## STAFF REPORT

Meeting Date:	August 28, 2025
Agenda Title:	Work Session – 35 S. Fifth Street
Requested Action:	Work session review of proposal to remodel the extant historic shed on the lot to include a rear addition to allow for a tenant.
Department / Agency Lead:	Community Development
Staff Lead:	Casey Squyres

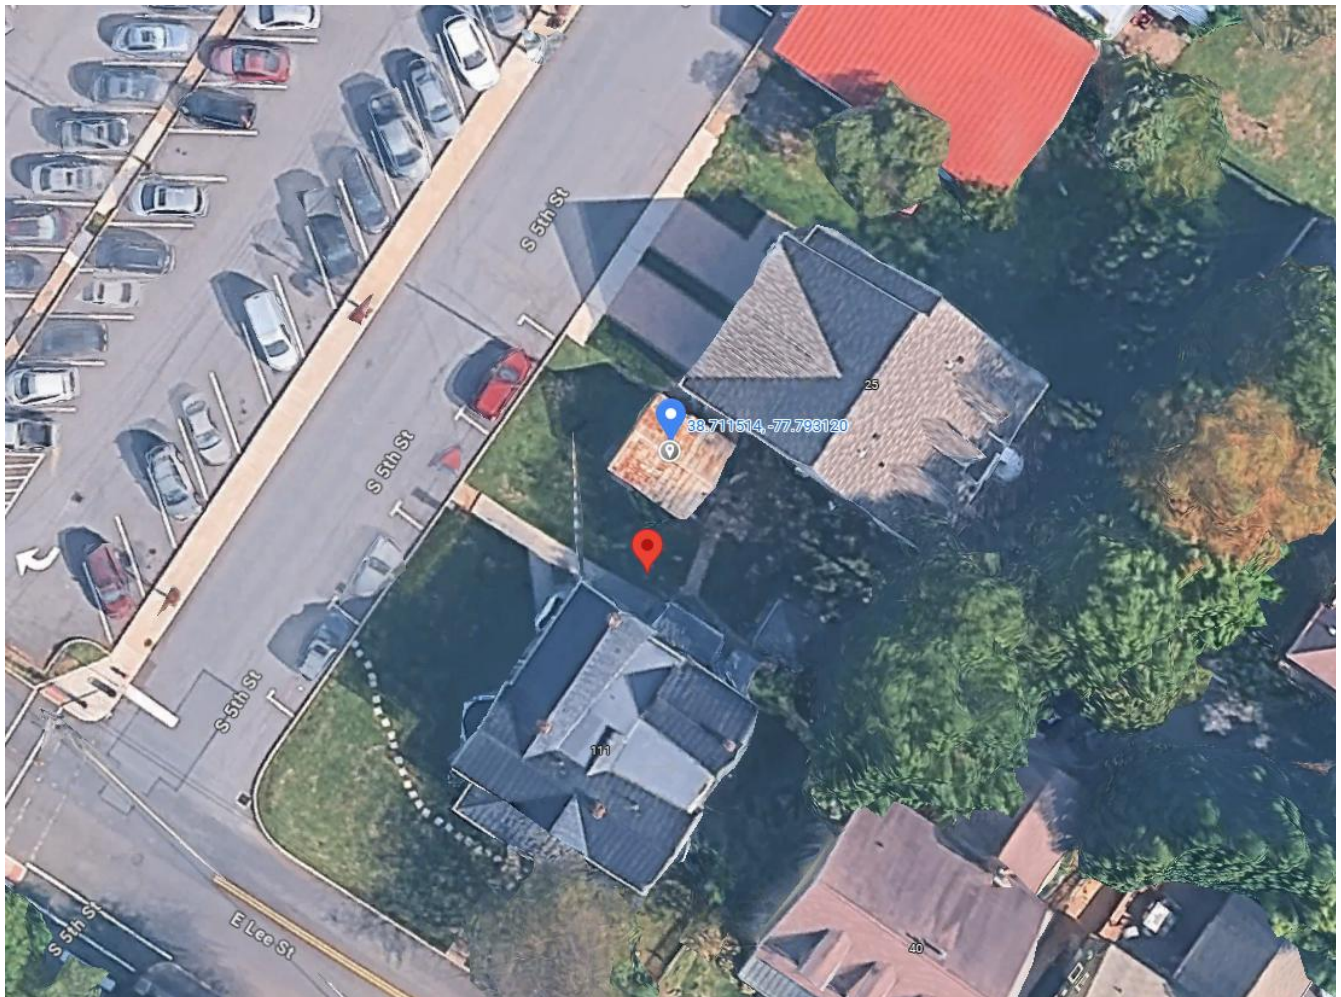
This 1-story front gabled shed has a metal standing seam roof with horizontal wood siding. The building is raised slightly on a brick coursed foundation. It's a vernacular outbuilding that was constructed ca. 1908 and is a contributing structure associated with the neighboring main house of the same date of construction at 111 E. Lee Street.
